UNITED STATES PATENT AND TRADEMARK OFFICE

| APPLICATION NO. | FILING DATE | FIRST NAMED INVENTOR | ATTORNEY DOCKET NO. | CONFIRMATION NO. |
|-----------------|-------------|----------------------|---------------------|------------------|
| 10/024,507 | 12/21/2001 | Donald E. Bobbitt | 42072 | 2198 |

Office Action Summary

DETAILED ACTION

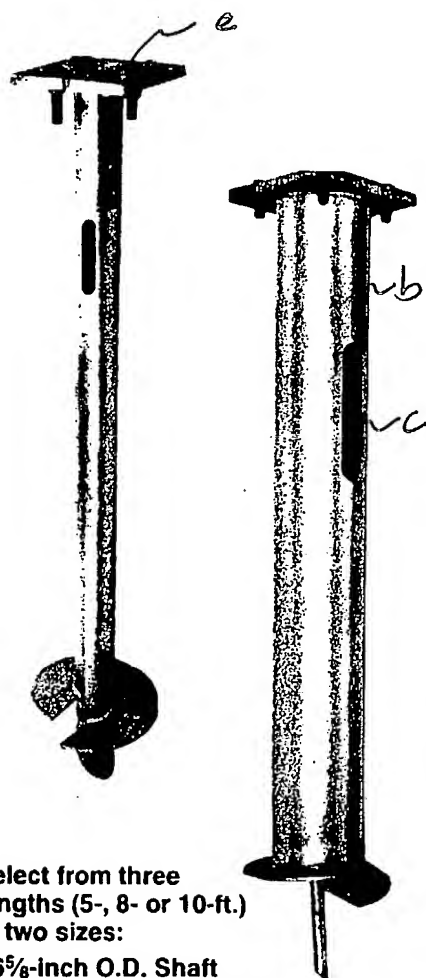
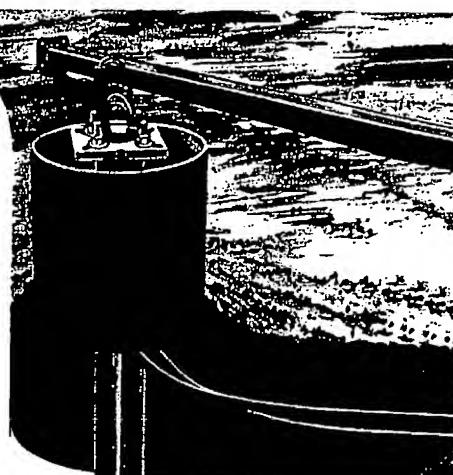
Hubbell Power Systems, Inc. (see attachment) teaches installing on site a lighting fixture foundation comprising a method of excavating a trench (a) having a depth and a width sufficiently receiving the lighting fixture foundation, the lighting fixture foundation comprising an elongated hollow shaft (b) having cableway openings (c) being precut to extend through opposite surfaces of the tubular wall of the shaft, wherein the cableway openings are aligned in a same lever, an anchor (d) at the lower end of the hollow shaft for driving and supporting the hollow shaft through the bottom the trench into the ground, a support member being a base plate (e) fixed to an axial upper end of the shaft, the base plate having notches (f) to receive bolts (g) for

releasably supporting a lighting assembly thereon, the support member having a passageway (h) in communication with the hollow shaft such that cableways are extended through the cableway openings in opposite directions and the through the passageway of the support member to the lighting assembly. Wherein, Hubbell Power System teaches the lighting fixture foundation being installed by obvious alternative steps of excavating a trench in suitable depth and width, anchoring the hollow shaft in the trench by a hydraulic rotary equipment, placing cableways supporting electrical wiring in the trench on opposite sides of the shaft, inserting the cableways into the cableway openings and extending upward through the passageway of the support member, mounting a lighting assembly being coupled to the support member, and connecting the electrical wiring of the cableways with the lighting unit supported by the light support.

Hubbell Power System fails to define the hollow shaft having cableway openings formed on opposite surfaces of the hollow shaft and not co-axial such that the cableways are laterally spaced from each other as claimed for receiving cables being substantially perpendicular to the longitudinal axis of the hollow shaft and extending spaced apart without interfering with one another. Gagliano teaches a foundation to be anchoring in ground, comprising a hollow shaft having a tubular wall (1) extending along a central longitudinal axis, a plurality of openings (4 or 5) extending substantially perpendicular to the central axis of the hollow shaft, wherein the openings include a first opening and second opening disposed on diametrically opposing sides of the hollow shaft, the first and second openings are substantially parallel and are non-coaxially laterally spaced each other for preventing the inserted tubular members (2) being interfered with one another. It would have been obvious to one of ordinary skill in the art at the time the invention was made to modify the light fixture foundation of Hubbell Power System Inc. having
